## WESTMEAD CATHOLIC COMMUNITY EDUCATION CAMPUS ATTACHMENT E - RESPONSE TO OPEN SPACE CLARIFICATIONS

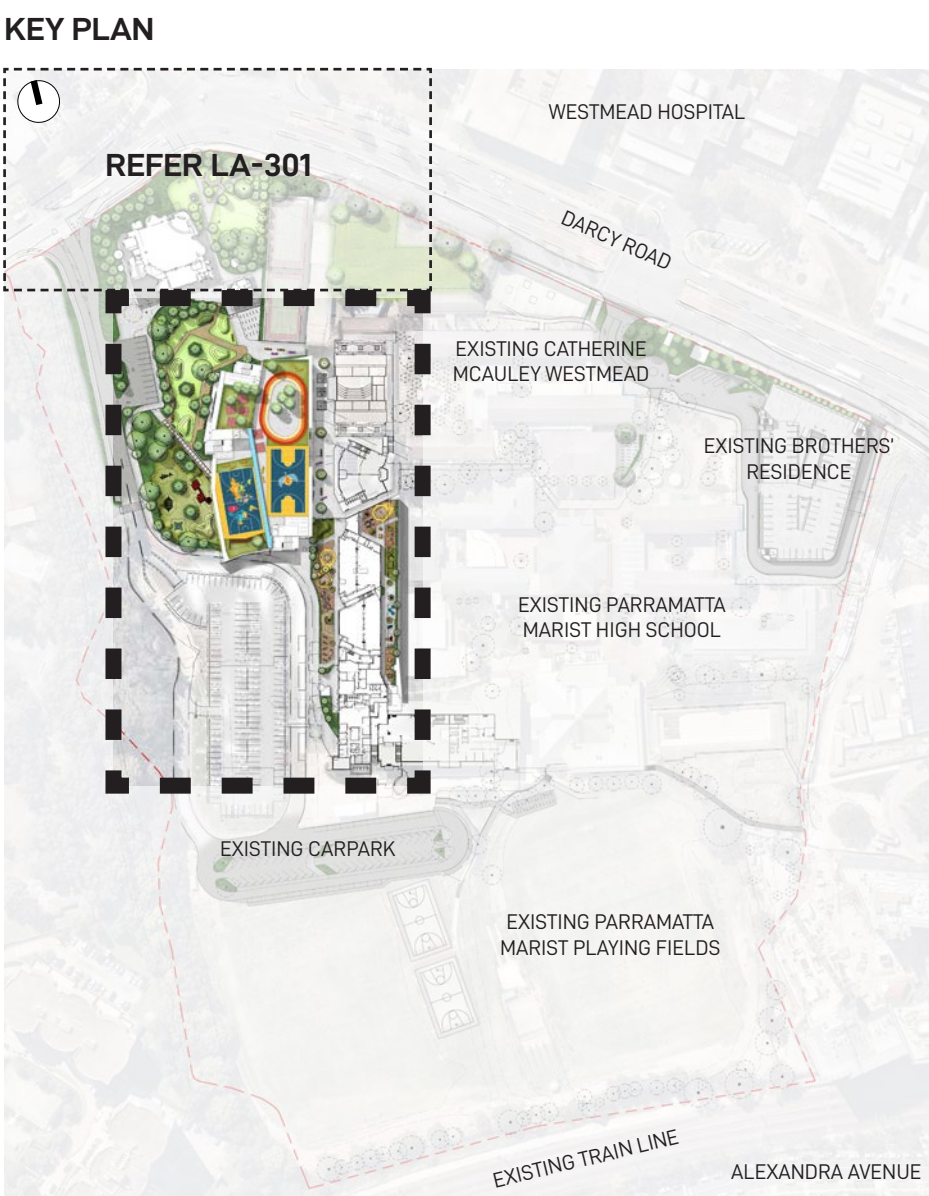
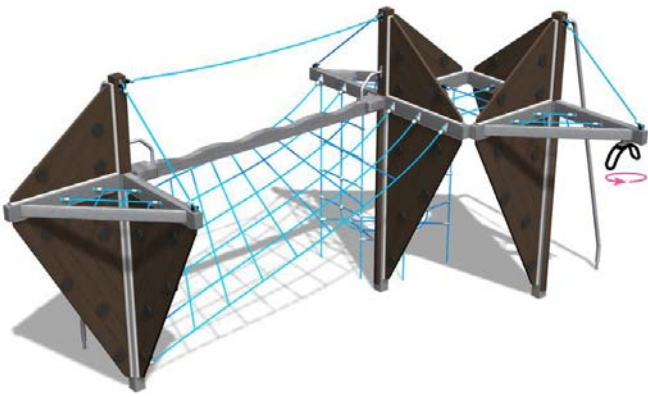
c	<p>Justify the inclusion of the circulation/access areas to the east and north of the primary school building within the open space calculations (area highlighted in blue below). The Department notes that this area includes circulation routes and bicycle racks and does not appear as functional play space.</p>	<p>The space to the north and east of the building forms part of the outdoor play area for the primary school – it is dedicated open space, providing a continuation of the adjacent undercroft area. It is not a circulation or access space.</p> <p>Plans of this area are attached. They demonstrate that it is a generous, unencumbered space. It will incorporate handball courts and hopscotch markings for active play, as well as tree plantings and fixed bench seating for passive recreation.</p> <p>The bicycle racks that were previously located to the north of the building have now been relocated to a consolidated bicycle parking area to the west of the existing playing courts. As described above, the bicycle parking area has been excluded from the ground level open space calculation. There is a corresponding, minor reduction in the quantum of open space at ground level. Notwithstanding, because the reduction is so minor, the area of open space per student continues to be 8.2sqm.</p>

The actual quantum of open space within the building (from Levels 1 – 5) is 7,867sqm. When combined with the ground level open space of 5,961sqm, which has been slightly reduced to remove the consolidated bicycle rack, as requested by DPIE, there is a total open space provision of 13,828sqm, or 8.23sqm per student (rounded down to 8.2sqm). This is shown in the schedule which has been prepared in response to Item b, and the revised Architectural Drawings provided at Attachment B of this RFI response.
